DCR PHOENIX HOMES

LOT #70
DIAMONDVIEW ESTATES 1

NEWINGTON
OPTIONAL CHEF'S KITCHEN
GARAGE RIGHT
MOUNTING HEIGHT: 96

REVISED: FEB 16-22

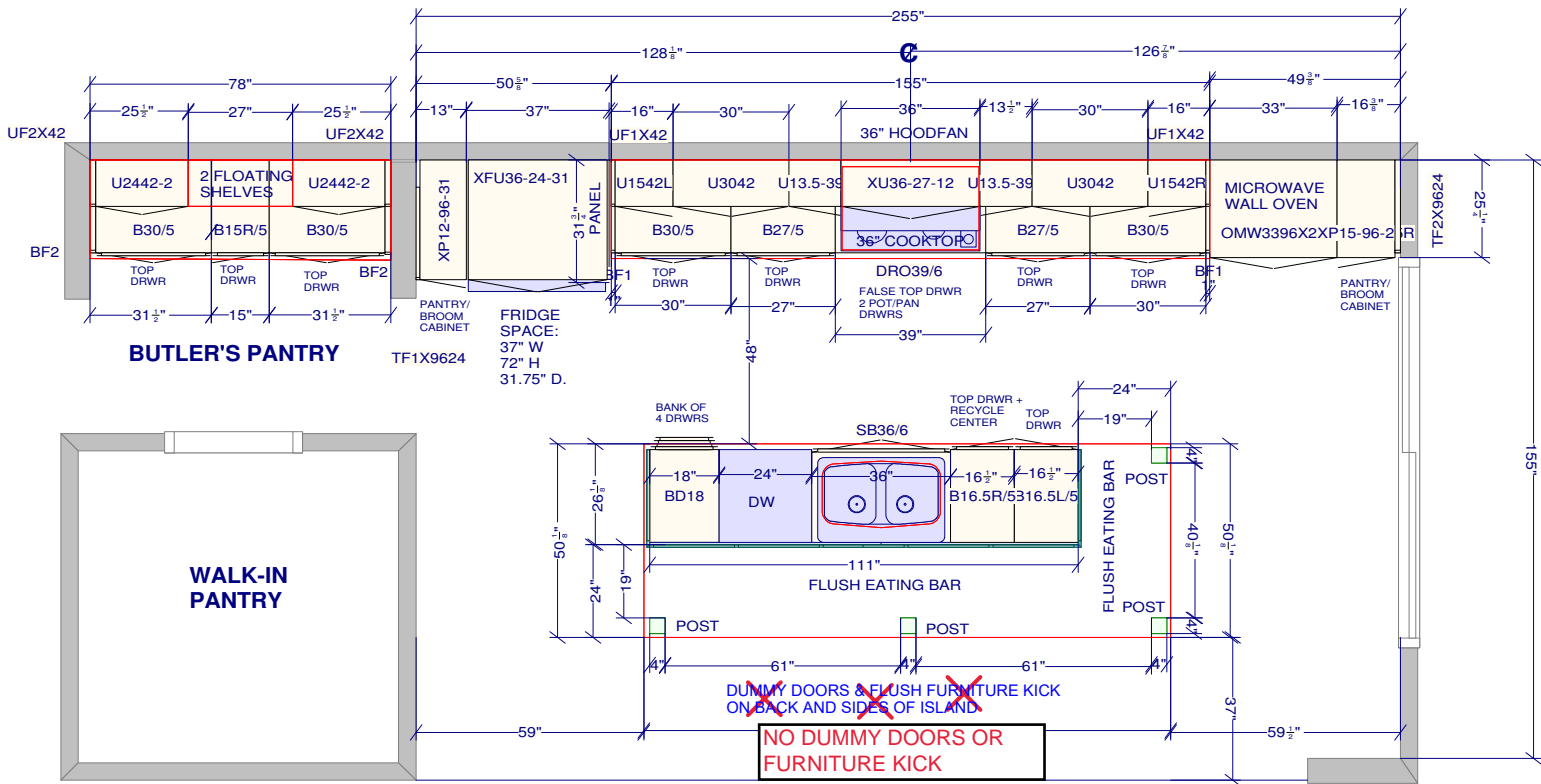
ISLAND - INCREASE HEIGHT OF CABINETS BY APPROX. 1 7/8" TO APPROX. 36 3/8"H (37 5/8"H. WITH COUNTERTOP); CABINETS TO BE INSTALLED ON 3 x 5/8" THICK MATERIAL; KICK PLATE, FLUSH FURNITURE KICK & SUPPPRT POSTS TO BE INCREASED IN HEIGHT TO SUIT
